**Service Bulletin**

**No. : MZ03-035**

**Model:** SA8260

**Subject:** Extension command Operation of "STANDBY ON "and "STANDBY OFF" is reversed.

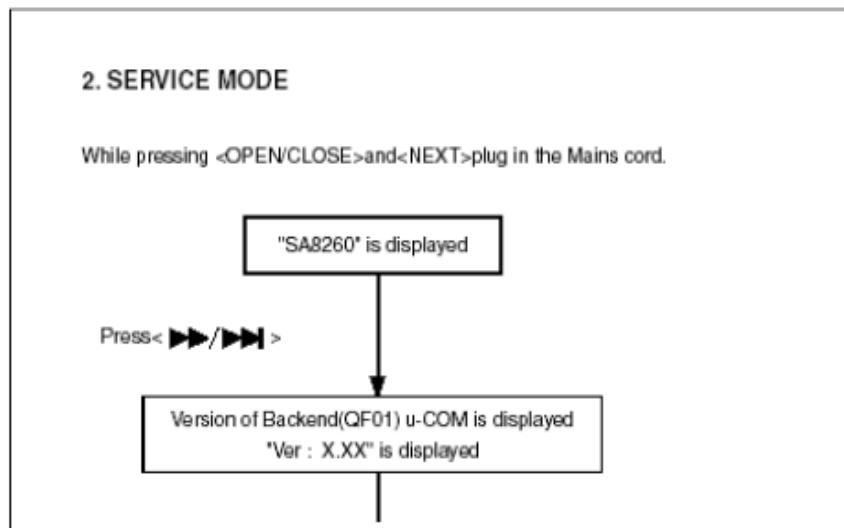
**Symptom:** When an extension command is used, this problem occurs. The supplied RC8260SA remote controller does not have the ability to send this command therefore, this problem does not occur when using RC8260SA remote controller.

**Solution:** Replace MICRO PROCESSOR QF01 on the PV16-SERVO PWB. Note: This problem was improved from VER 0.51 on. Before replacing QF01 please check the version of QF01 in the unit. Version number can be confirmed through SERVICE MODE, (Refer to service manual page 2).

Ref #	FORMER		NEW	
	Description	Part Number	Description	Part Number
QF01	CPU	HU01AKF00F	CPU	HU01AKF02F
